**La Rosa Pump Station Rehab**  
**Solicitation Number: CO-00314-SM**  
**Job No.: 18-6001**

**ADDENDUM 2**  
**1/30/2020**

**BASE BID:**  
 1. REFER TO PRICE PROPOSAL ITEM NO. 2B FOR BASE BID QUANTITY.

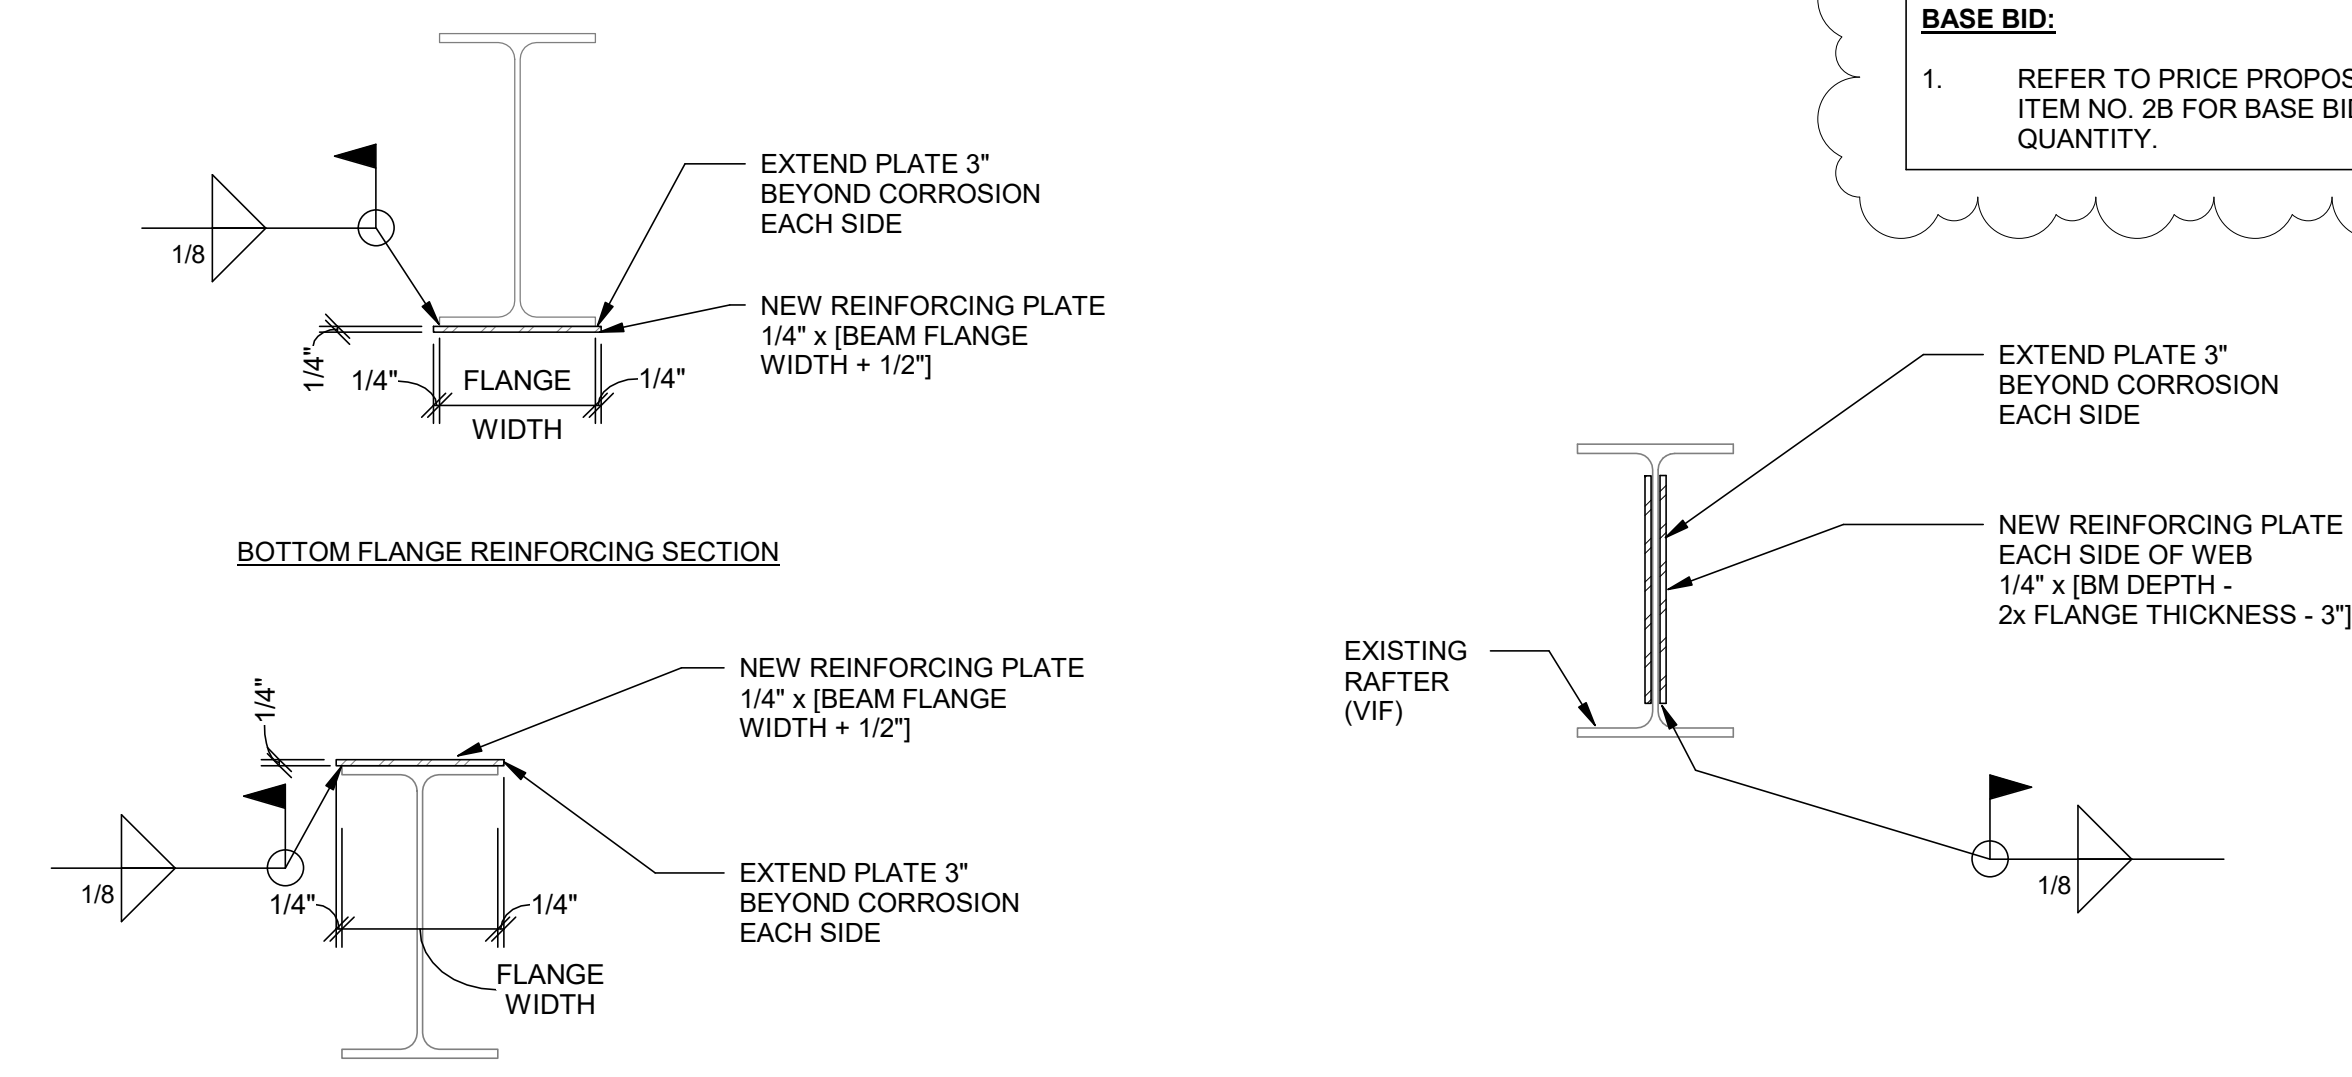
18. Bid Item 3B shows a quantity of 20 EA. for the interior perimeter angle brace replacement, but Detail L on S-206 has a note that says to base bid on 64 EA. Please confirm the actual quantity to be included in the bid.

Response: Detail L on S-206 has been updated, refer to drawing S-206 – STRUCTURAL CROWS NEST DETAILS in the CHANGES TO THE PLANS of this Addendum.

**E-107**

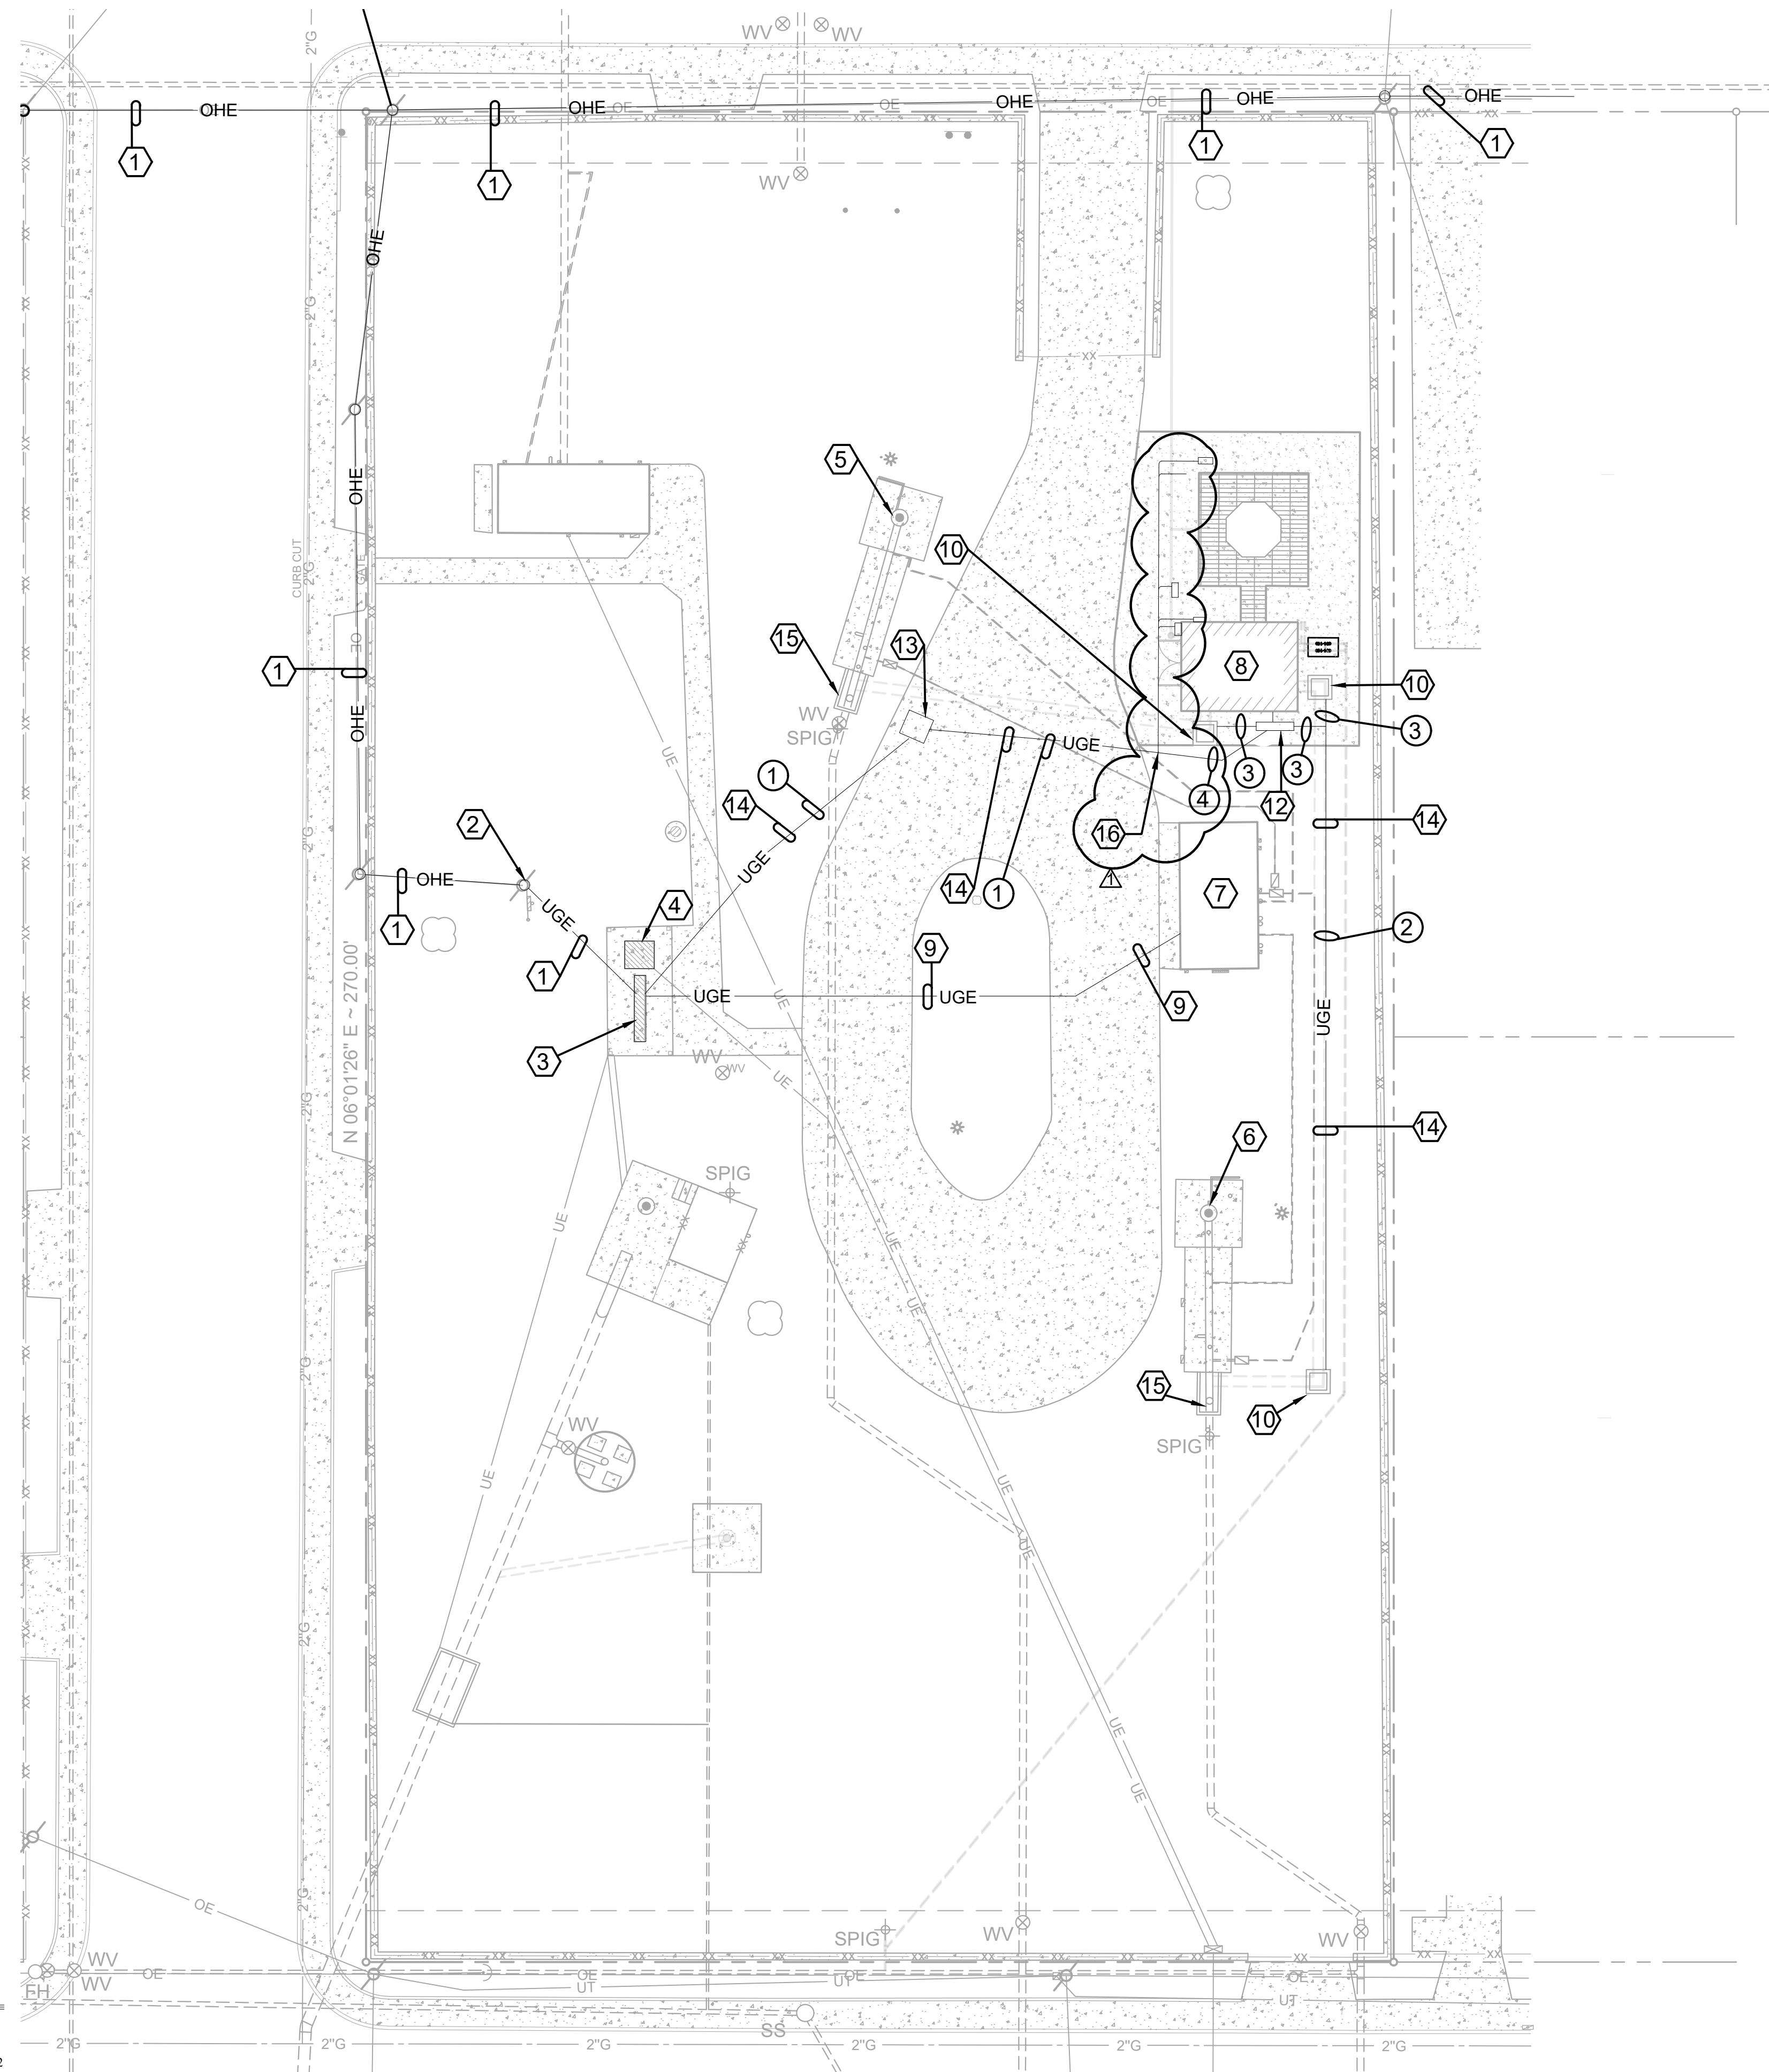
12. Drawing E-107, there is a new Junction Box for Heat Trace to Tank Piping (Keyed Note 23) on the north side of the GST. It seems to be at the location of where the existing ¾" PT & manway which are to be demolished (Ref. DWG D-301 detail 1.) Please review and advise if the Heat Trace JB is required. There is a Heat Trace Junction Box on the south side of the GST where the new taps are located.

Response: The junction box on the north side of the tank labeled as Keyed Note 23 was removed, refer to drawing E-107 – ELECTRICAL RENOVATION SITE PLAN LA ROSA in the CHANGES TO THE PLANS of this addendum.
